## **Access Compliance Report Public Rights-of-Way** (Curb Ramps)

Intersection ID: 51539 Main Street: TRIEG DR **Cross Street: GLENBURN LN** Location: N ADA ID: 740B71CE1B54 Ramp Type: PerpDiag Initial Pass/Fail: Fail **Overall Compliance: No Severity Score:** 22.5

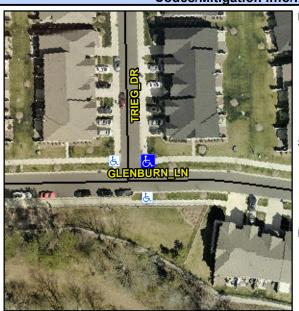
Possible Solutions: Remove & Replace Curb Ramp With Two New Directional Ramps or Equivalent. Surveyor Notes: N/A PROW/ADA: Not Found, R304.5.1, R304.2.2, R304.5.3

Field Measurements/Component Compliance					
Compliance Description		Data	Comp	oliance Description	Data
N/A	Ramp Length (in)	65.0	No	Ramp Slope (%)	9.8
No	Ramp Width (in)	44.0	No	Ramp XSlope (%)	3.7
N/A	Flare Type LT	N/A	N/A	Flare Type RT	N/A
N/A	Flare Slope LT (%)	N/A	N/A	Flare Slope RT (%)	N/A
N/A	Flare Traversable LT?	N/A	N/A	Flare Traversable RT?	N/A
N/A	Landing Length (in)	N/A	N/A	DWS Provided?	N/A
N/A	Landing Width (in)	N/A	N/A	DWS Contrast?	N/A
N/A	Landing Slope (%)	N/A	N/A	DWS Length (in)	N/A
N/A	Landing X Slope (%)	N/A	N/A	DWS Full Width?	N/A
N/A	Landing Curb? (Y/N)	N/A	N/A	DWS Offset (in)	N/A
N/A	Shared Landing?	N/A			
N/A	Gutter Ponding?	N/A	N/A	Gutter Slope (%)	N/A
N/A	Gutter Lip Ht (in)	N/A	N/A	Gutter X Slope (%)	N/A
N/A	Painted X Walk1?	No	N/A	Painted X Walk2?	No
	X Walk 1 Direction	To W		X Walk 2 Direction	To S
N/A	X Walk 1 Width (in)	N/A	N/A	X Walk 2 Width (in)	N/A
	X Walk 1 Slope (%)	1.8		X Walk 2 Slope (%)	2.9
